Street Tree Review Panel Report for A38 Bromsgrove Route Enhancement Programme (BREP)- Scheme E

Appendix A – Scheme General Arrangement B2367222-JAC-HGN-E-DR-CH-0001 C01 Scheme E

Figure 1 – Extract of Scheme E Landscaping proposals

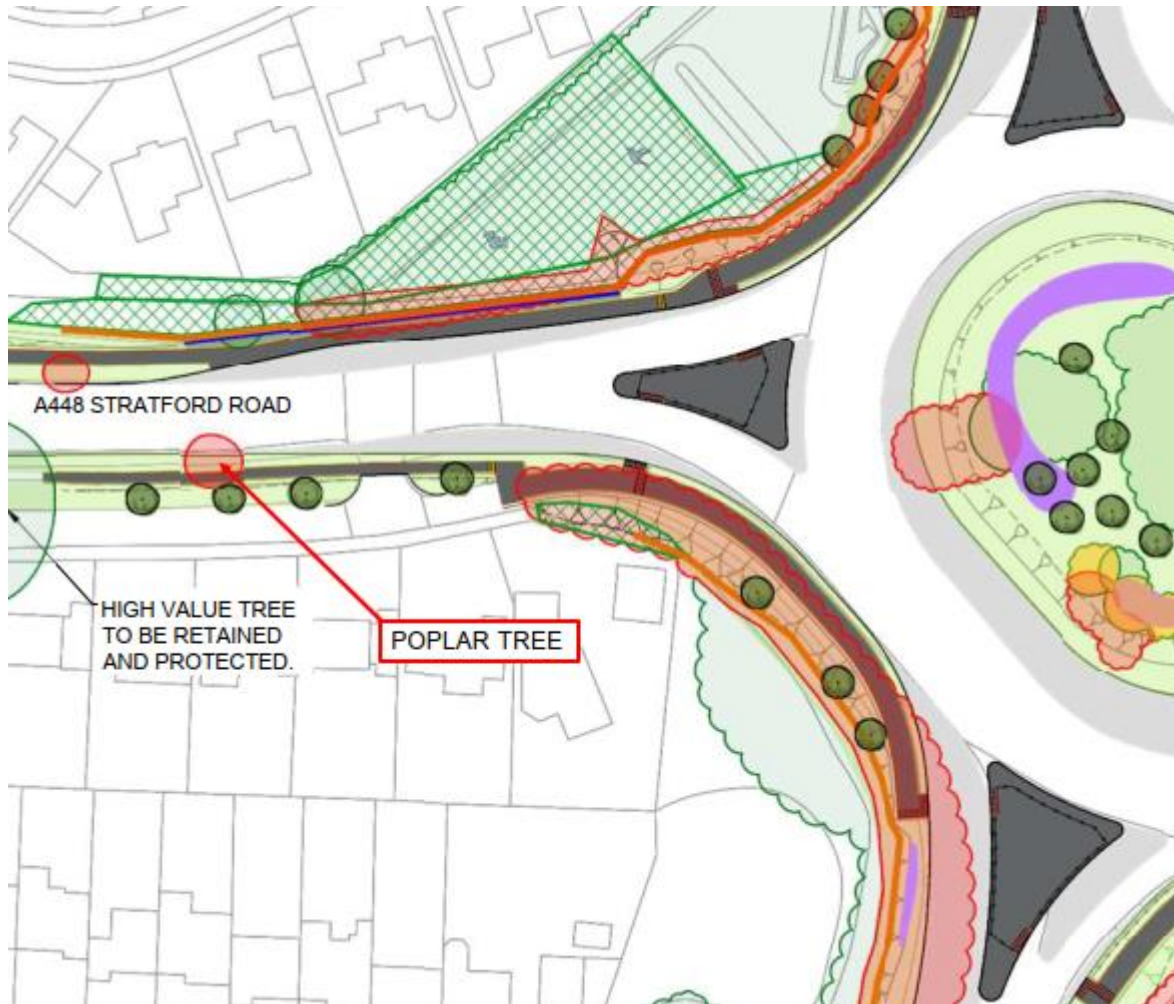
The following construction activities are required in very close proximity to the poplar tree: A new kerbline, new carriageway widening, carriageway resurfacing, footway, verge works and landscaping. The tree would cause great difficulty in delivering the works safely due to its location. Without the removal of the poplar tree, the works in this area could not be implemented, which would cause significant problems to the operation of the roundabout through reducing capacity. This would be contrary to the Business Case and would prevent the objectives of BREP being achieved.

The tree would be significantly compromised through the necessity to excavate around it. This would cause the root structure to be damaged and significantly increase the probability of it becoming unstable and hazardous.

The tree is located very close to the existing carriageway. This provides an immovable obstruction in the event that a driver loses control of their vehicle as they exit the roundabout. As a large improvement scheme, which has complied with detailed design (and relevant design standards) and Road Safety Audits, it would not be acceptable to allow such a hazard to remain. Accident data has been reviewed and during the 2000-2017 period three collisions were reported on Stratford Road and attributed to loss of control. A driver had a collision with a tree on Stratford Road in 2022 which was attributed to driver error.

- The Panel asked whether the junction capacity improvements could be achieved if the additional lane was not provided (and therefore the poplar would not need to be removed). The Client Project Manager confirmed that the provision of the lane is essential for the junction improvements to be realised and that this junction is of particular importance in delivering key BREP objectives.

- The Panel asked if the additional capacity could be provided to the North rather than on the South where tree is located: The Client Project Manager confirmed that it was not possible due to land and geometry constraints.

- The Panel asked whether it would be feasible to reduce the length of the merge lane from the roundabout. The Client Project Manager confirmed that it wouldn't be acceptable to reduce the length of the merge length due to safety standards.

In the verge area in the vicinity of the poplar tree, 4 x 3.5m-4.25m *Acer campestre* (Field Maple) trees will be planted, albeit a suitable distance from the carriageway.

The Street Tree Review Panel agreed with the recommendations of this report to remove the poplar tree.
